Document Update Notification

TITLE: EMERGENCY RESPONSE/
NOTIFICATIONS

CHANGE NO: 027-00-0

ENTERGY OPERATIONS INCORPORATED
ARKANSAS NUCLEAR ONE

ATTACHMENT 6

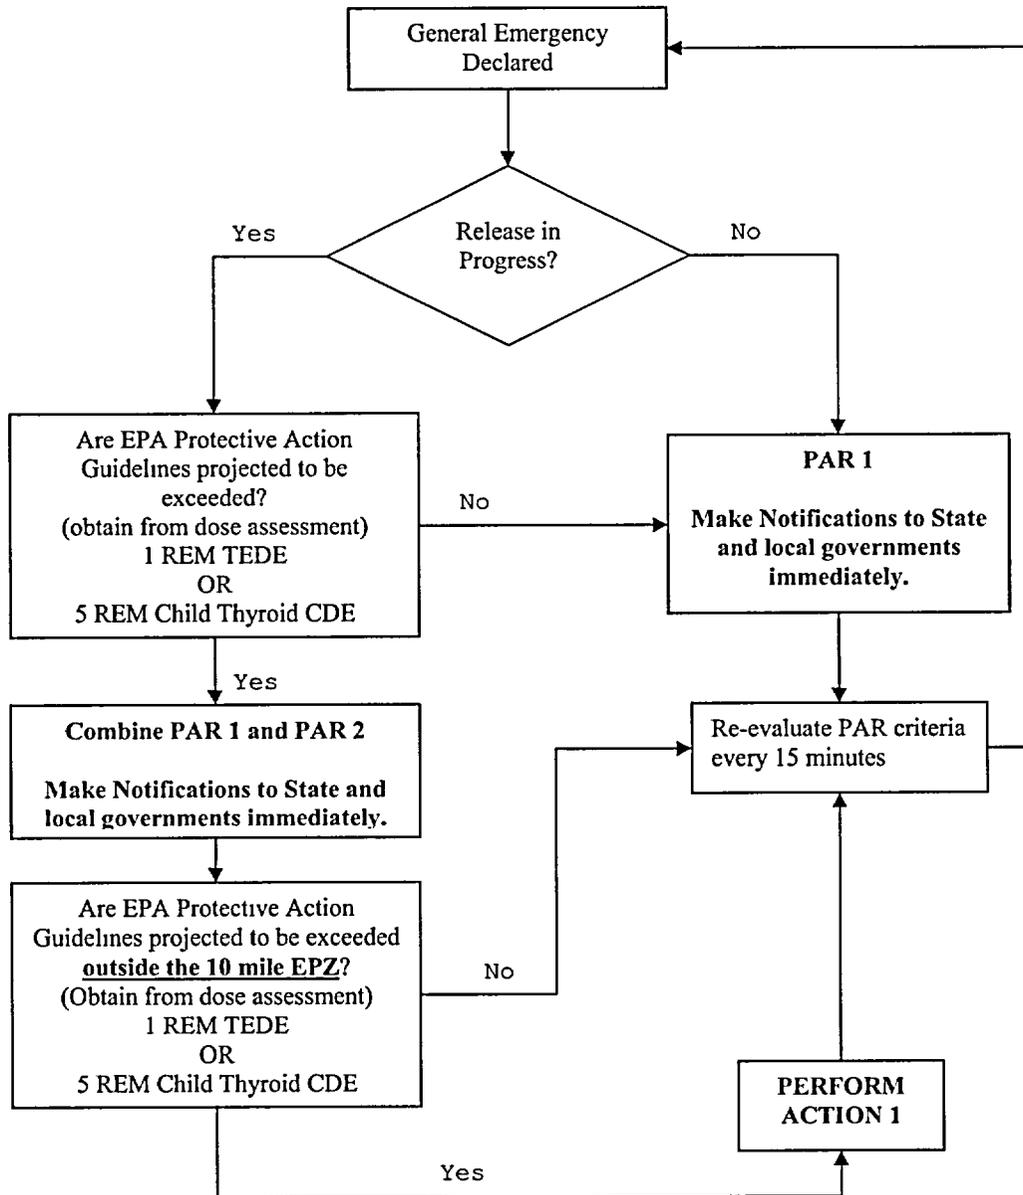
| AFFECTED SECTION: (Include step # if applicable) | DESCRIPTION OF CHANGE: (For each change made, include sufficient detail to describe reason for the change.) |
|---|--|
| Attachment 6 Page 1 | Deleted criteria for PAR 2. Deleted reference to PAR 1 (2 mile radius and 5 miles downwind). Changed PAR 2 (5 mile radius and 10 mile downwind) to PAR 1. Changed PAR 3 (radiological PAR) to PAR 2. Added criteria for release outside the 10 mile EPZ and added Action 1 (instructions to determine protective actions outside 10 mile EPZ). Added instruction to reassess PAR every 15 minutes. |
